**Economic and Social Council**Distr.: General  
14 January 2011Original: English  
English and French only

**World Forum for Harmonization of Vehicle Regulations****Working Party on Lighting and Light-Signalling****Sixty-fifth session**

**Collective amendments–Regulations Nos. 48 and 23****Proposal for the [06] series of amendments to Regulation  
Nos. 48 (Installation of lighting and light-signalling devices)****Submitted by the Chair of the task force on courtesy lamp of the  
Working Party on Lighting and Light-Signalling\***

Model A

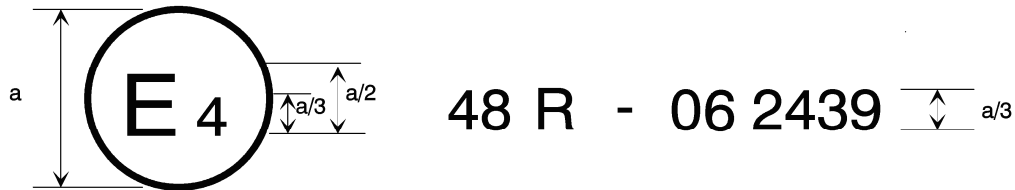
The above ...Regulation No. 48 as amended by the [06] series of amendments. The approval number indicates that the approval was granted in accordance with the requirements of Regulation No. 48 as amended by the [06] series of amendments.

Model B

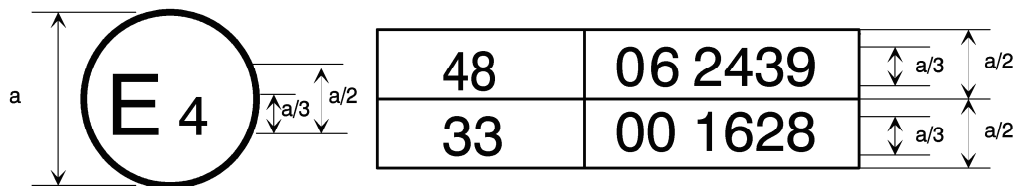
The above ...Regulation No. 48 as amended by the [06] series of amendments and Regulation No. 33.<sup>1</sup> The approval number indicates that, at the dates when the respective approvals were given, Regulation No. 48 was amended by the [06] series of amendments and Regulation No. 33 was still in its original form."
